Dear authors,

Many thanks for submitting a revised version of the manuscript.

I have done a thorough revision, and although this revised version has improved a lot (both text and figures), there are a number of issues that need attention. Please see the uploaded document for more details.

Fig. 1: this is very nice figure now. Some comments

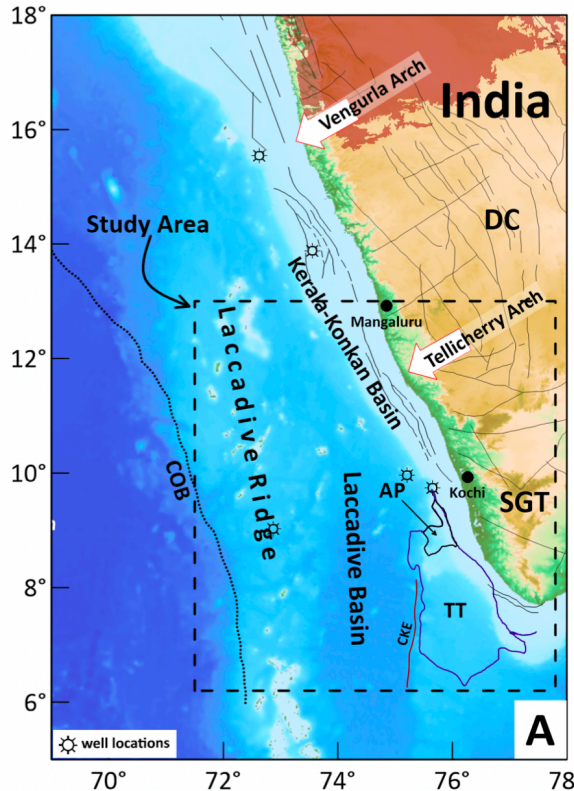
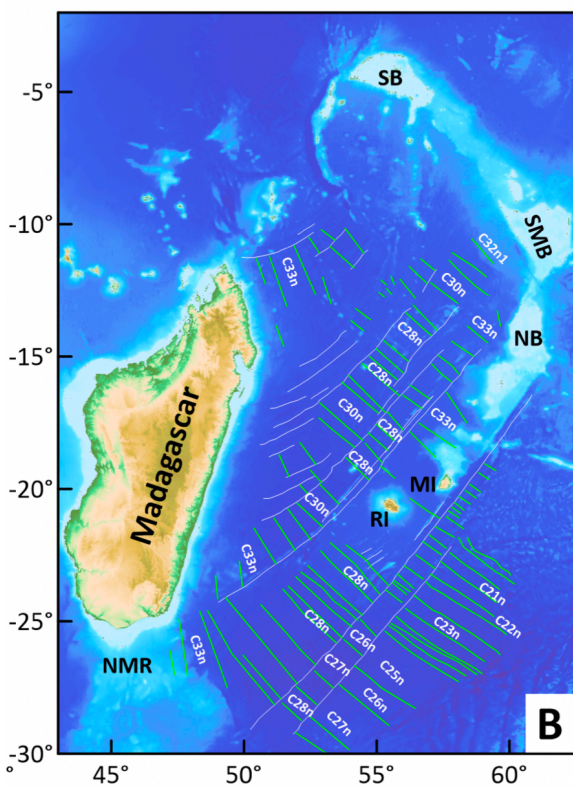
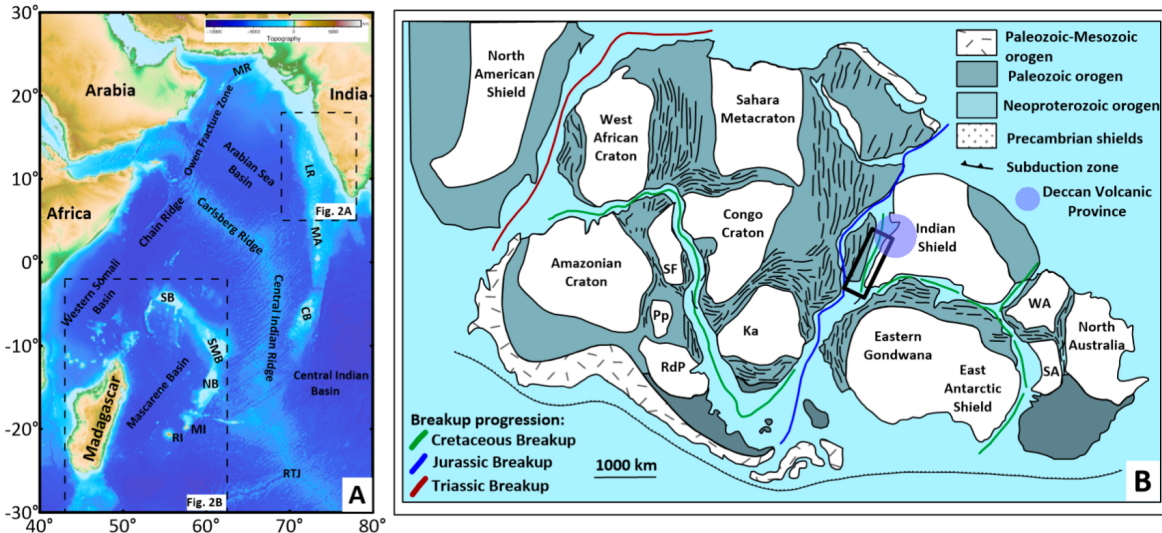
- In panel A, the altitude scale is too small (text is not readily readable).
- In panel B, there are numerous abbreviations for the various plates/cratons, which should be specified in the caption
- In Panel B, I would recommend using a bright red dot, instead of a blue dot to indicate the Deccan Volcanic Province
- It may be useful to merge figures 1 and 2 (by simply putting the two panels of Fig. 2 below those of Fig. 1).
 - see what it may look like on next page
 - Caption text can be merged, saving space.
 - Font size may have to be adjusted in the panels derived from Fig. 2
 - See comment on the order of the panels in Fig. 2
